Village of Summit Plan Commission Thursday, October 17, 2024 5:30 p.m. At the Summit Village Hall, 37100 Delafield Road

10/17/2024 Plan Commission Meeting

THE GATHERING
SINGLE-FAMILY SUBDIVISION - CONCEPT PLAN
10/17/2024 Plan Commission Meeting
Lurvey Property (SUMT0714999001)

Sheet Name:
**LANDSCAPE
PLAN**

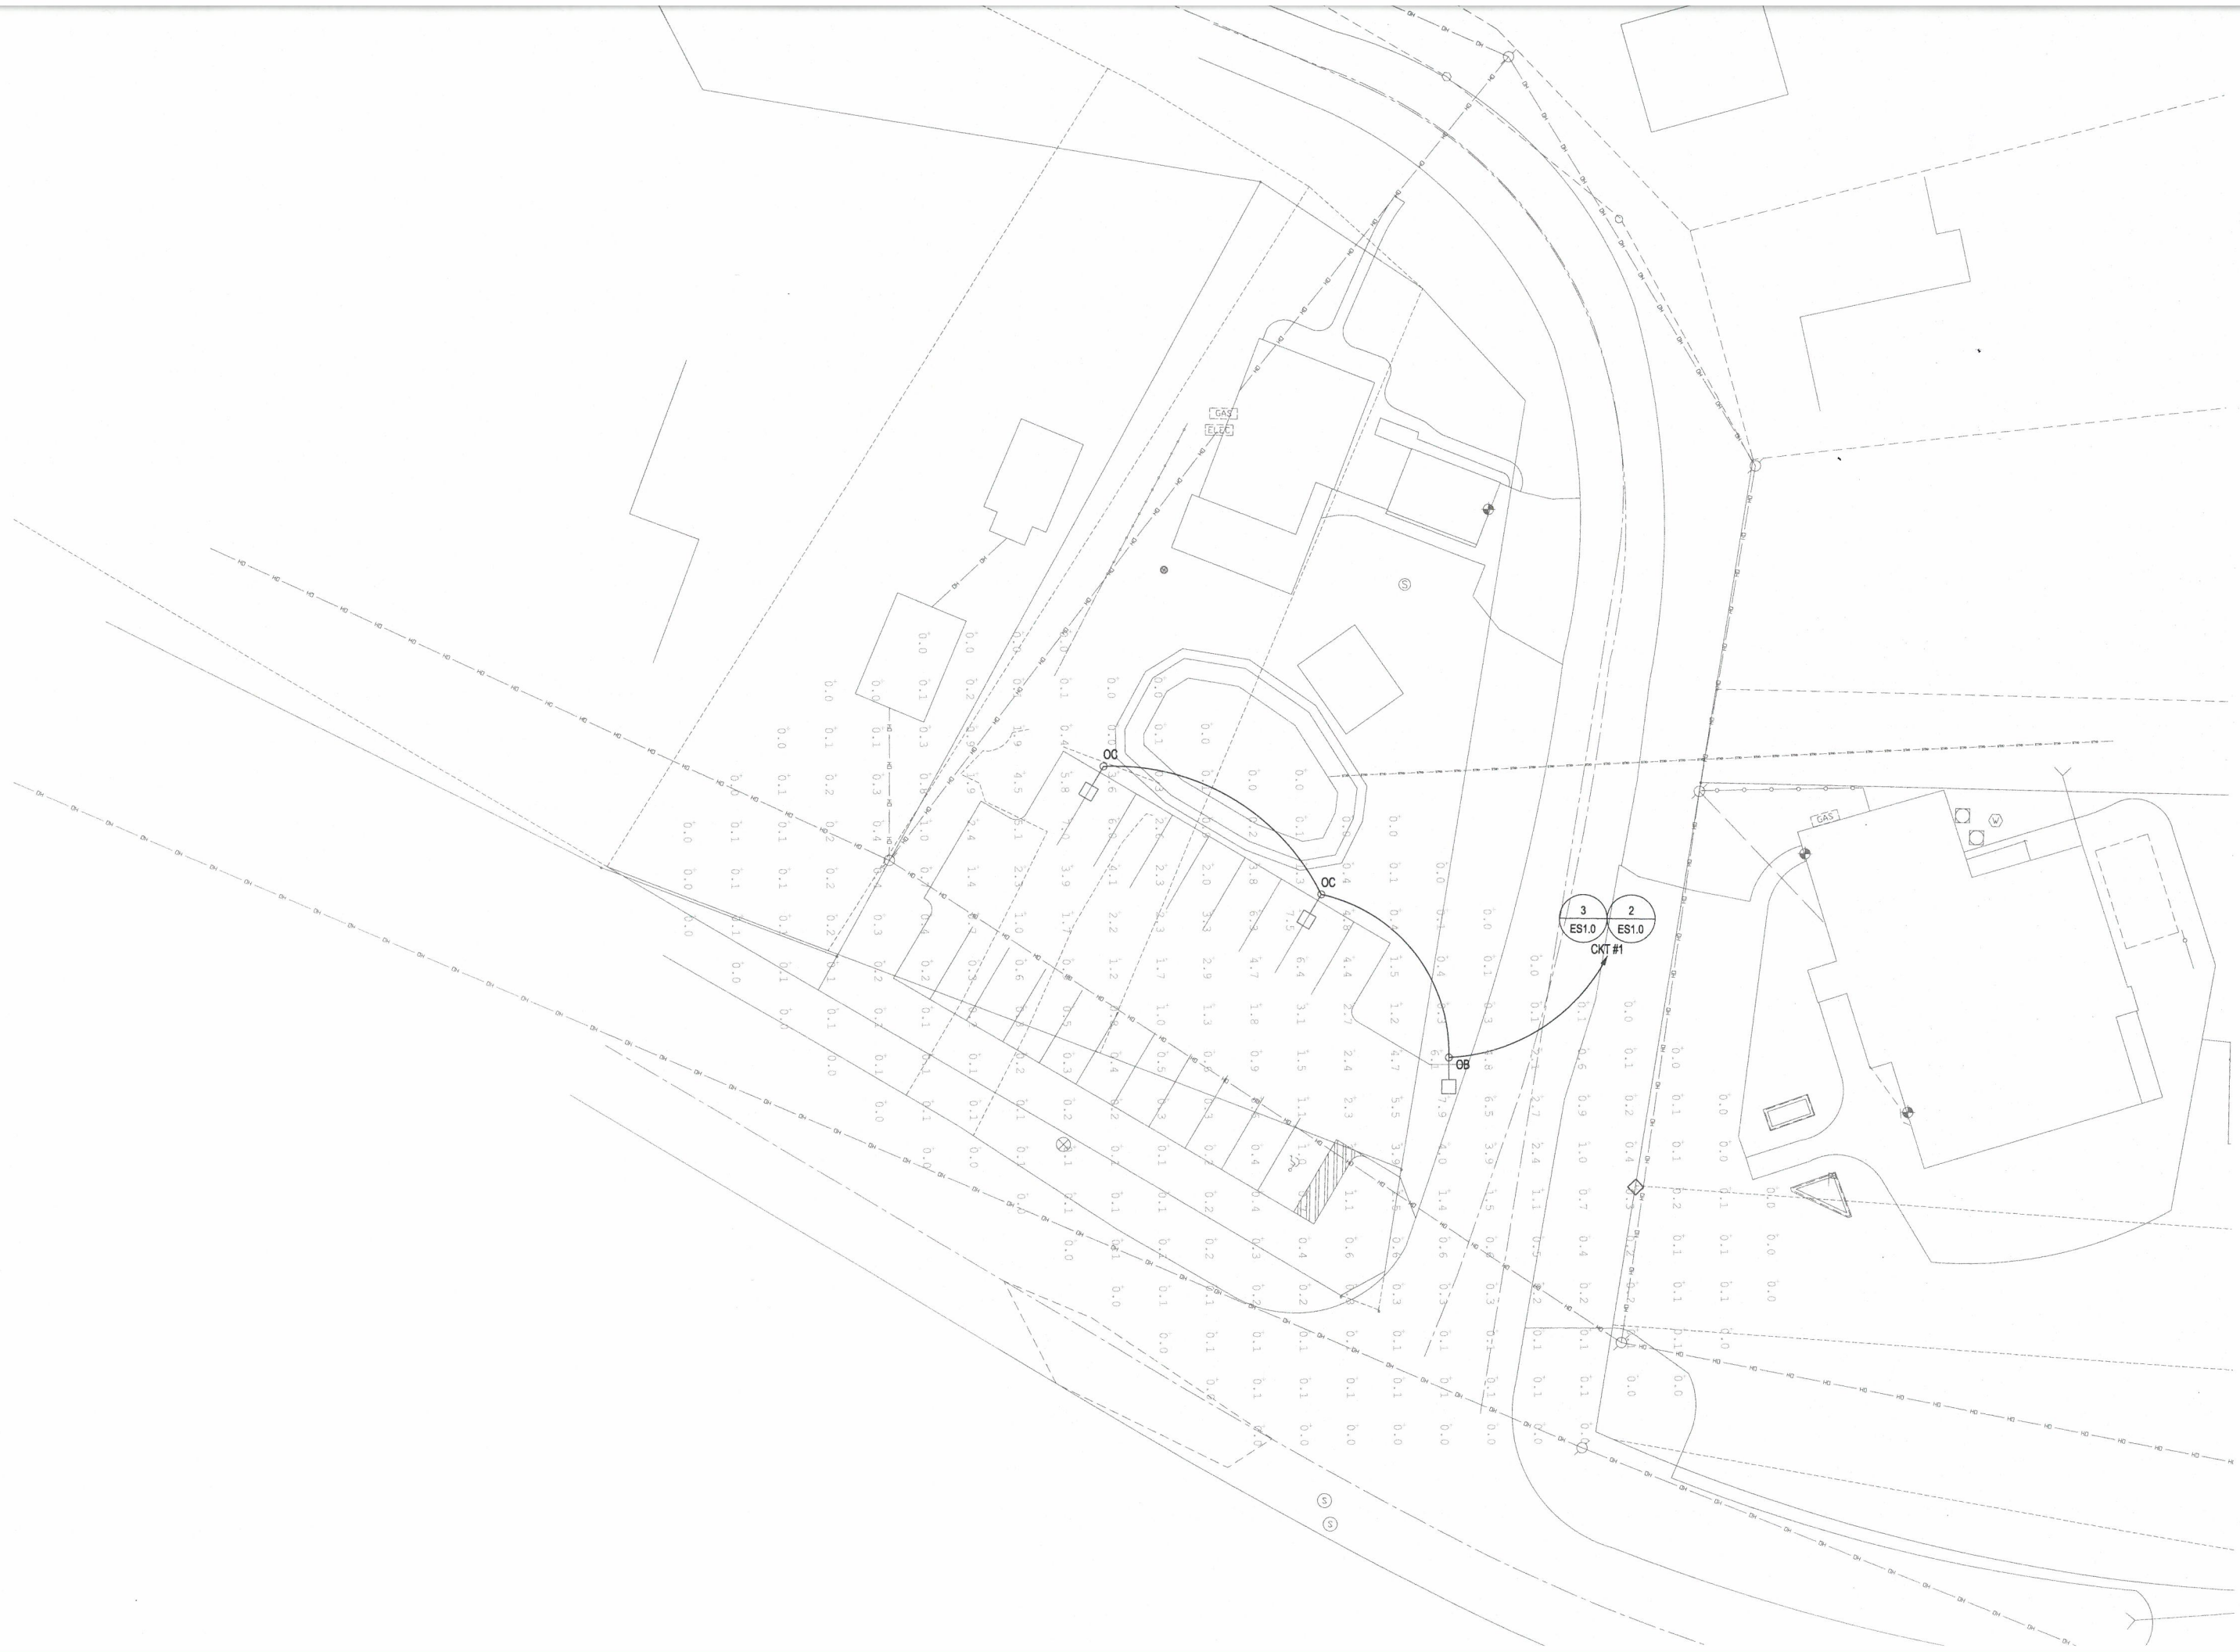
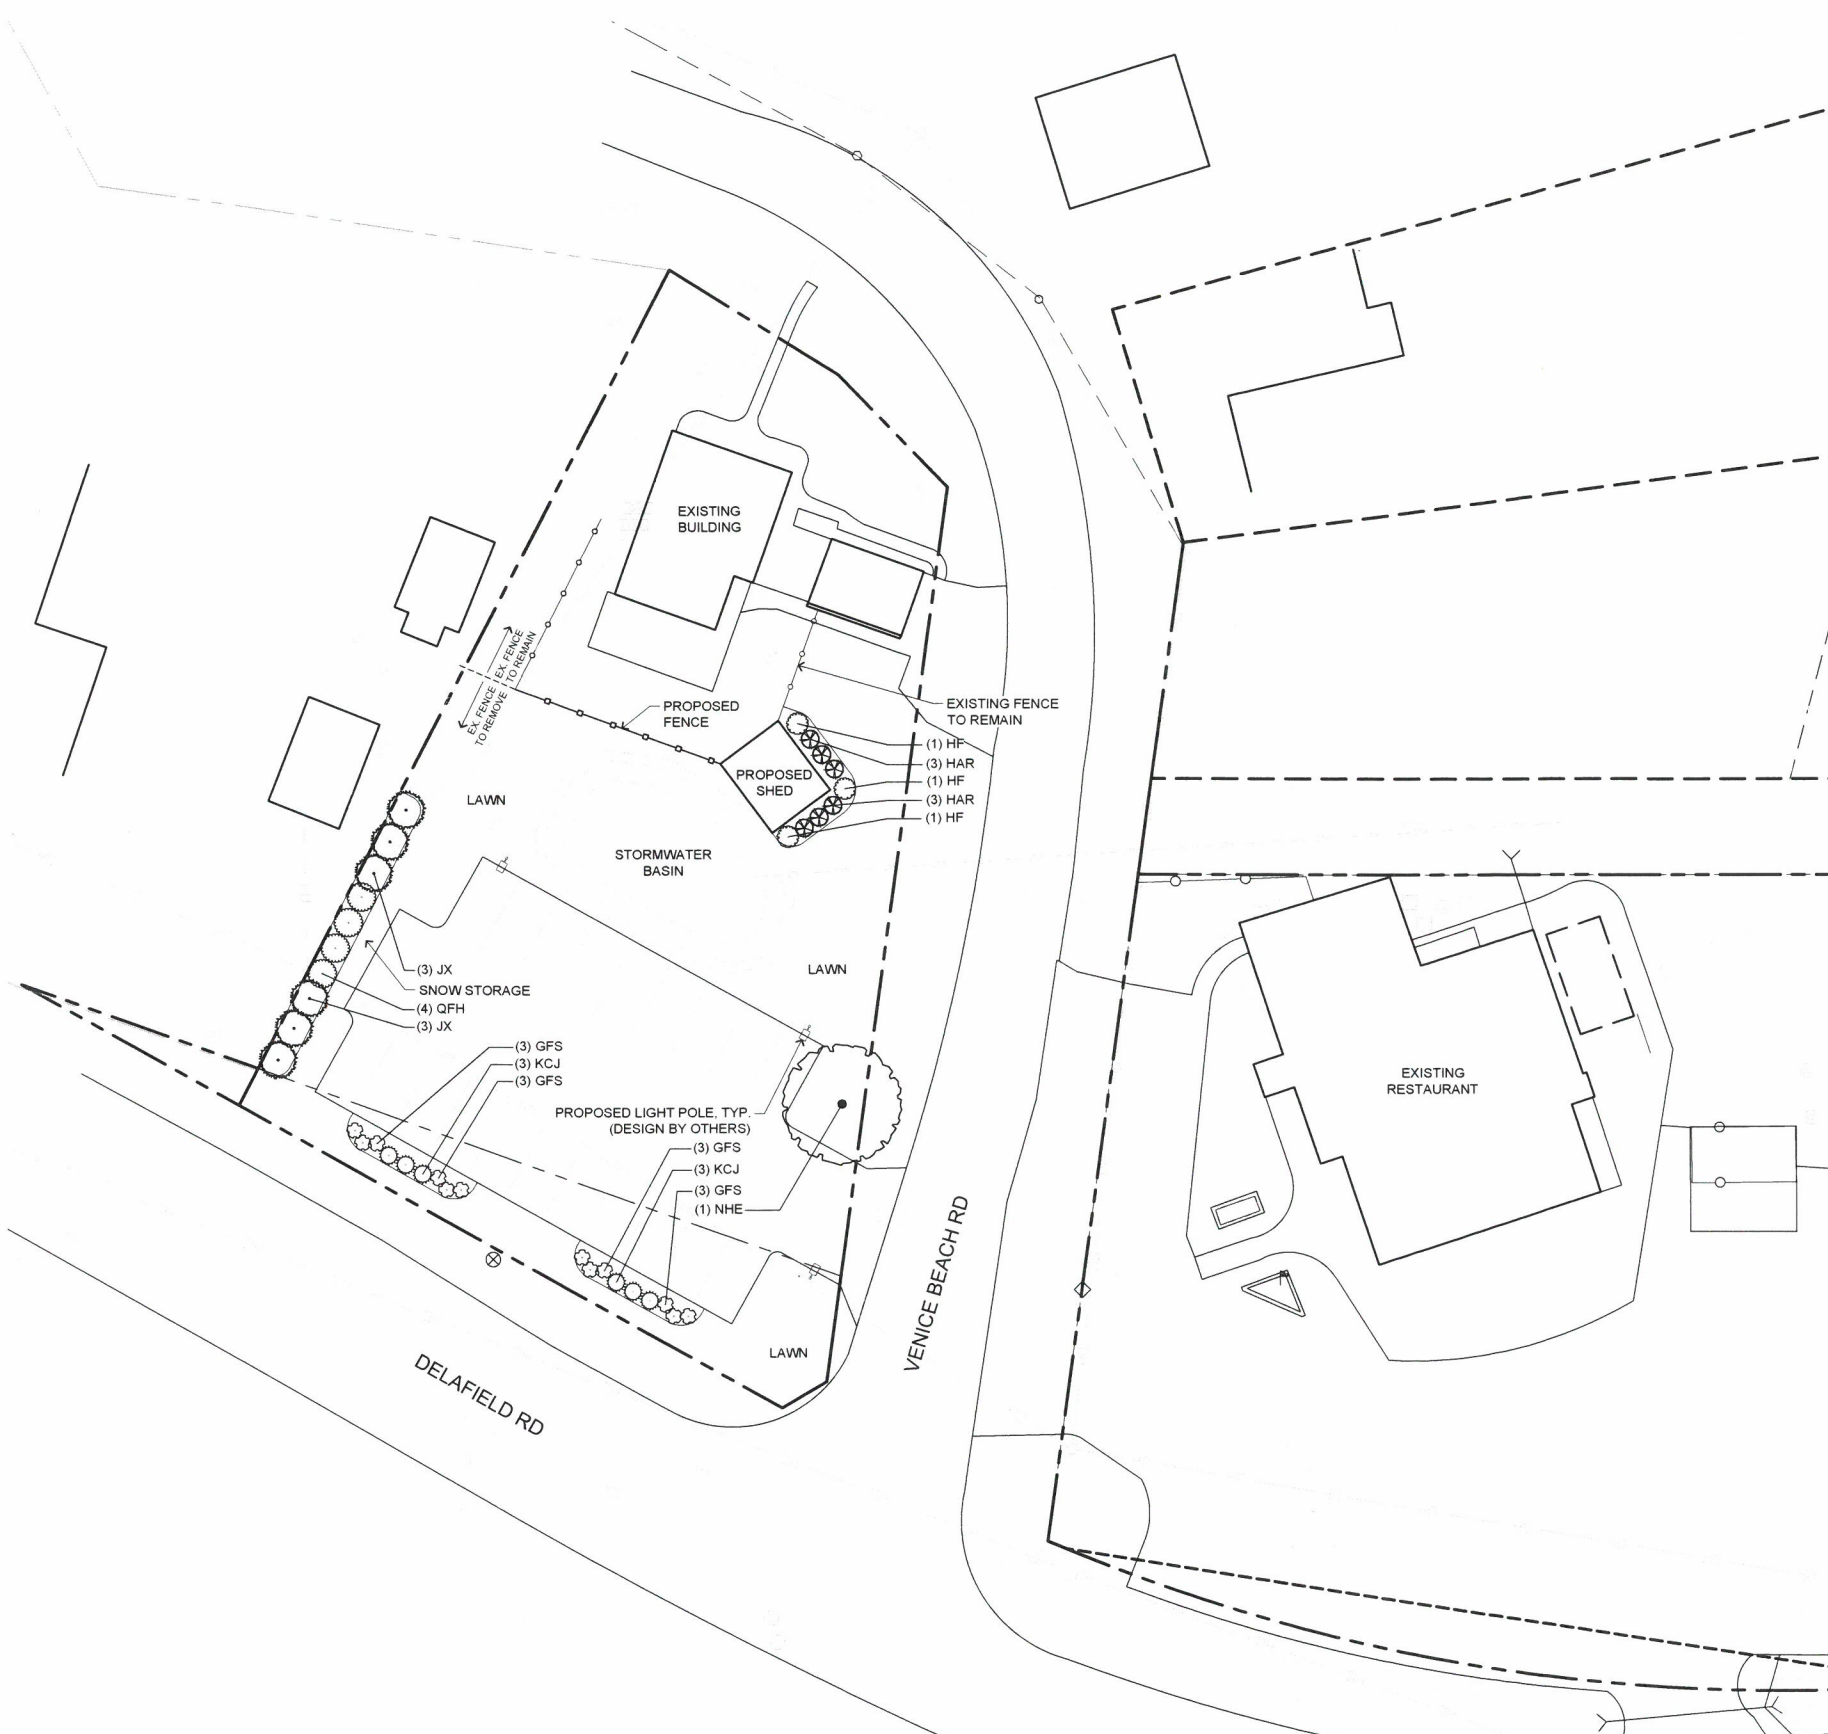
- 5.) The landscape plan shall be implemented prior to any customers using the parking lot. The four deciduous shrubs along the west lot line shall be replaced with evergreen shrubs that are at least 4 ft. in height.

The applicant is also proposing to plant 6 evergreen trees and 4 deciduous shrubs along the west lot line. There will be two areas of shrubs planted between the parking lot and CTH DR. There will also be one elm tree planted just outside of the road right-of-way of Venice Beach Road. At such time the applicant proposes to construct the shed, additional plantings will be placed at the base of the shed.

ALED Field-Adjustable Area Lights

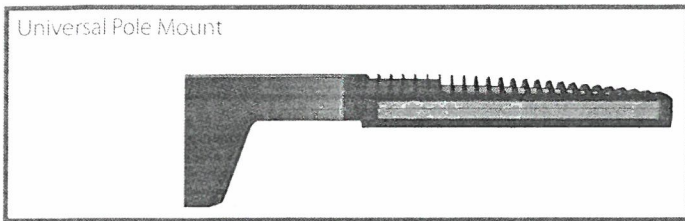
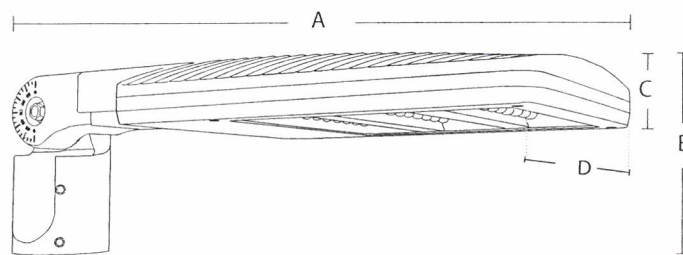
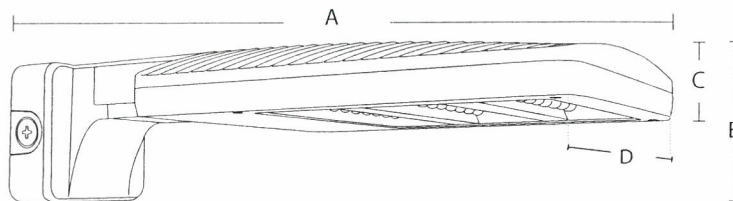
- 4.) The lighting details, including total height, type, materials and color, shall be submitted to Plan Commission for review and approval prior to the installation of lights. The lights shall be turned off within one hour of business closing.

There will be three light poles. The poles will be 15 ft. in height with an additional base. The height of the base was not included with the plans. The applicant did not indicate which features will be used. The applicant has been asked to present the specific details related to lighting at the meeting.
